ADDENDUM #7

Date: October 21, 2026

Project: New Locker Room Facility and Renovations to the
Existing Concession and Tennis Facilities Project at the
Merrillville High School
276 E 68th Place
Merrillville, Indiana 46410

Architect's Project #26027

SHEET
C1.3.0
- D

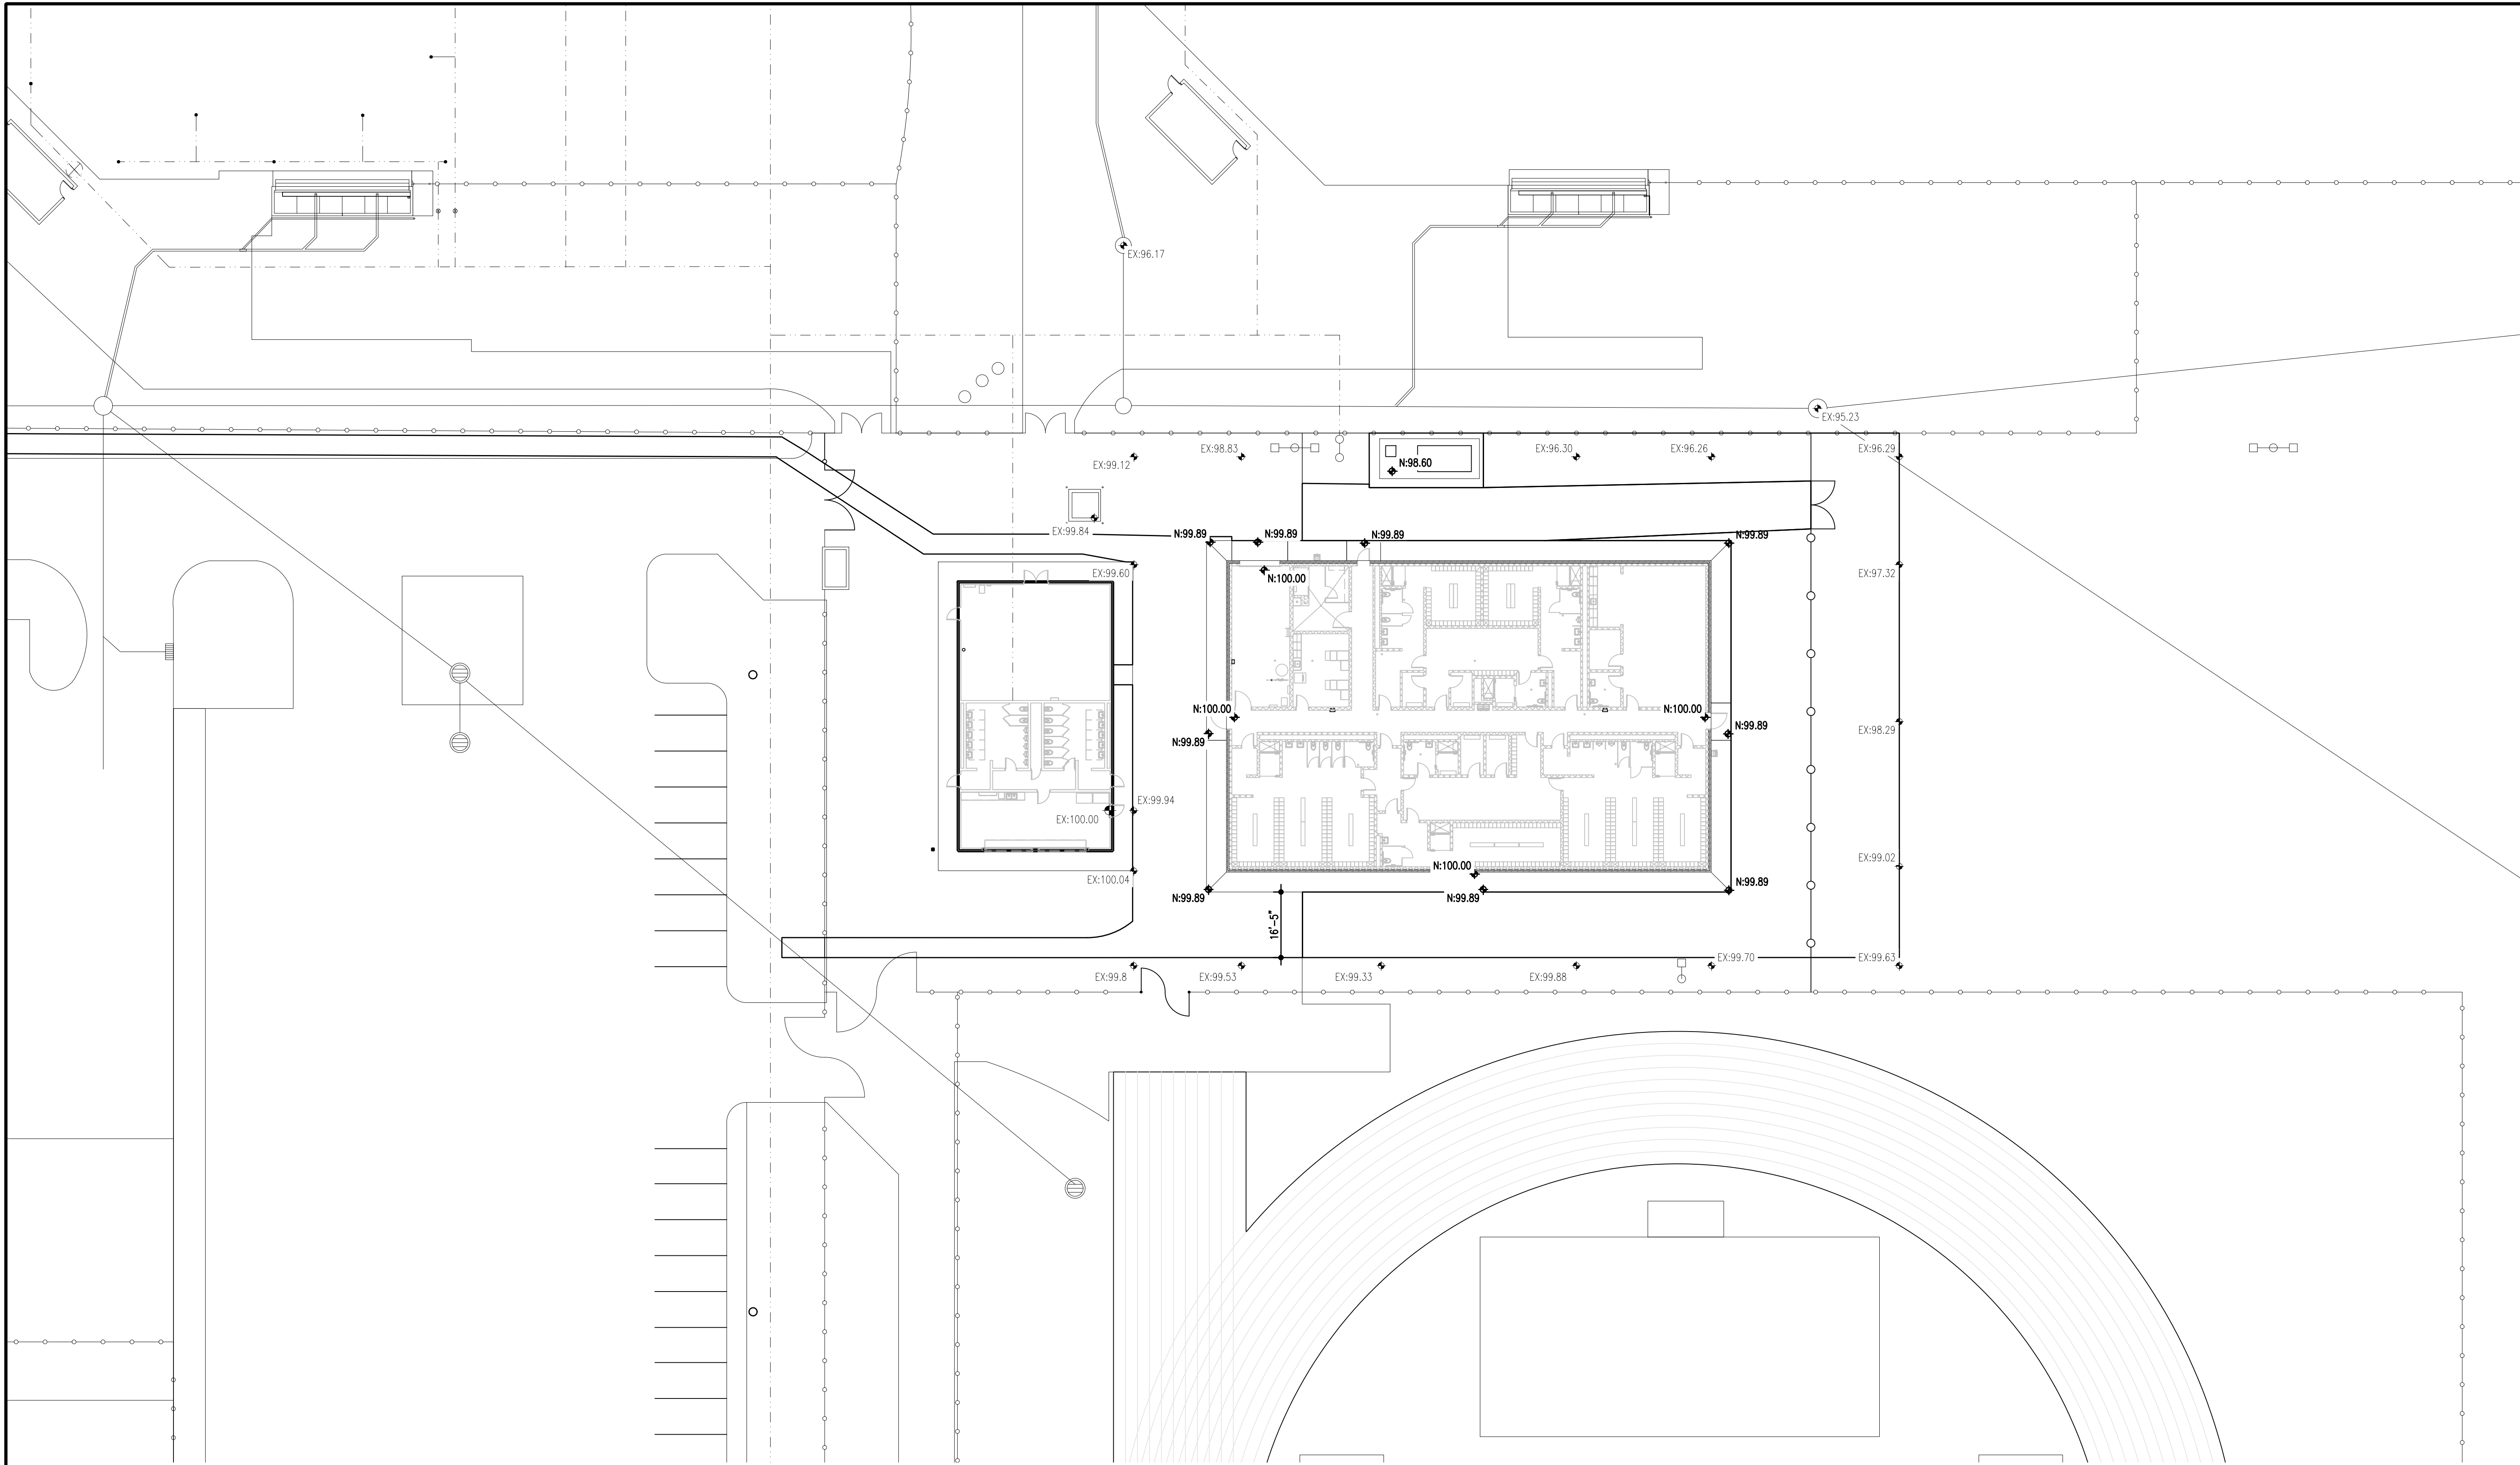
12. See attached Revised Drawing Sheet C1.3.0-D – Partial Utility Plan – New Construction – High School Substation #2 - This plan shows clouded and tagged revisions dated 10/21/2026.

SHEET
S
2.1.1-A

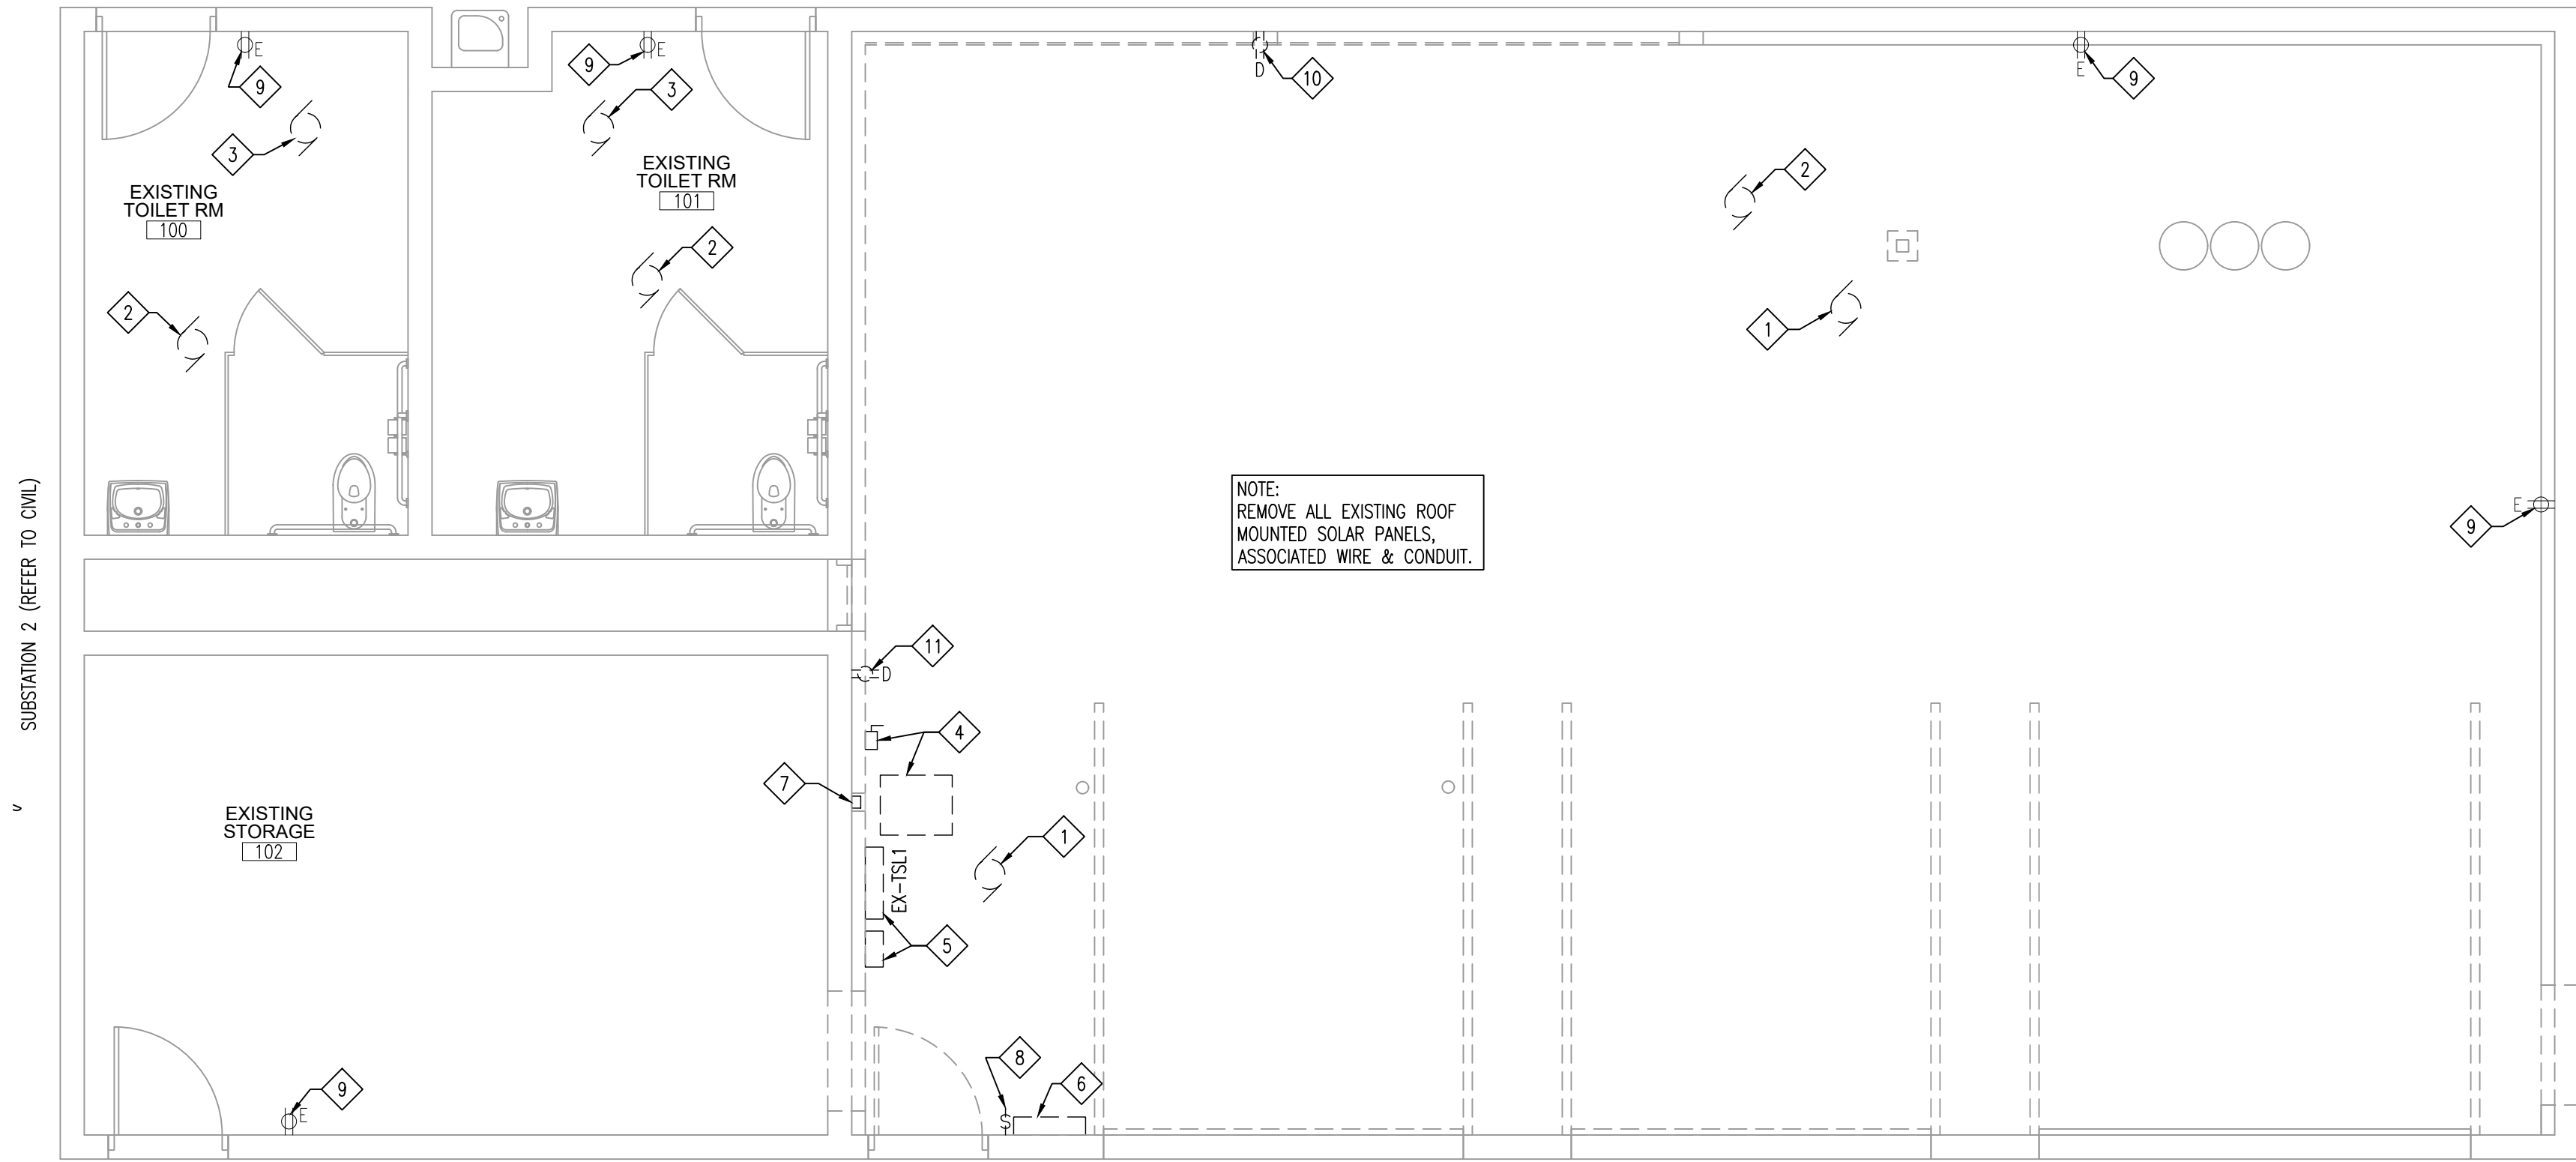
20. See attached Revised Drawing Sheet S2.1.1-A – Partial Structural Plan – Area A - This plan shows clouded and tagged revisions dated 10/16/2026.
21. Drawing Sheet E2.1.2-A – Partial Power Plan – Area A – **Revise Electrical Power Plan New Keyed Note #6 to provide 12 strand single-mode fiber optic cable in leu of three(3) fiber optic cables.**
